Prairie Island Nuclear Generating Plant  
1717 Wakonade Drive East  
Welch, MN 55089

Prairie Island Nuclear Generating Plant's Fifth Six-Month Status Report in Response to March 12, 2012 Commission Order Modifying Licenses with Regard to Requirements for Reliable Spent Fuel Pool Instrumentation (Order Number EA-12-051) (TAC Nos. MF0832 and MF0833)

### **Prairie Island Nuclear Generating Plant, Units 1 and 2 Fifth Six-Month Status Report for Implementation of Order EA-12-051, Order Modifying Licenses with Regard to Requirements for Reliable Spent Fuel Pool Instrumentation**

### **Prairie Island Nuclear Generating Plant, Units 1 and 2 Completion of Required Action by NRC Order EA-12-051 Reliable Spent Fuel Pool Instrumentation**

Figure 1 – Locations of SFPI Equipment

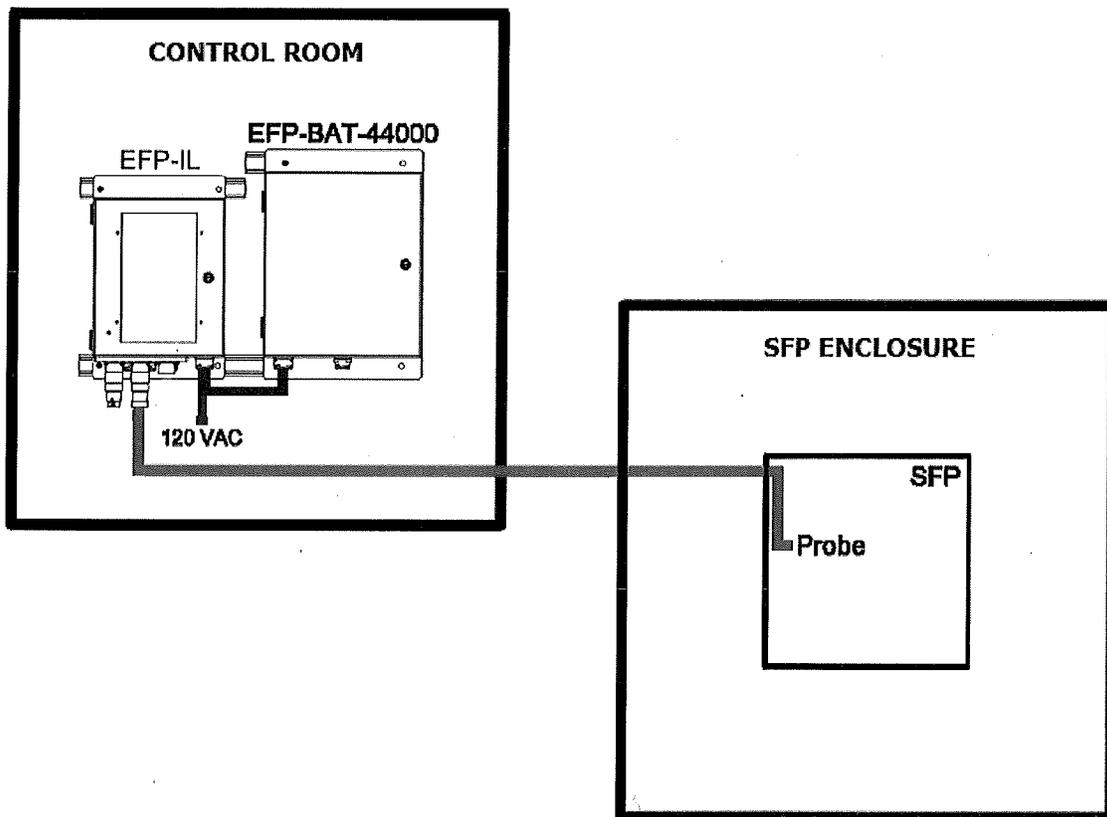
**Please provide a clearly labeled sketch or marked-up plant drawing of the plan view of the SFP area, depicting the proposed routing of the cables that will extend from the sensors toward the location of the read-out/display device.**

NSPM has installed a fixed probe in each of the two connected spent fuel storage pools at PINGP. The probes are mounted in the northwest corner of SFP #1 and in the northeast corner of SFP #2. Both the primary and backup displays are located in the control room. The primary SFPI cable routing from the SFP #2 to the Unit 1 Control Room uses existing penetrations and cable trays. The backup SFPI cable routing from the SFP #1 to Unit 2 Control Room uses existing embedded conduits, penetrations and cable tray system. Cable for each channel is routed in separate conduits and cable trays to provide additional redundancy.

Field walkdowns, performed as part of the design process, verified the cable routing met the channel separation requirements. Documents and drawings that provide the SFP instrument system design and layout sketches were provided to the NRC for audit.
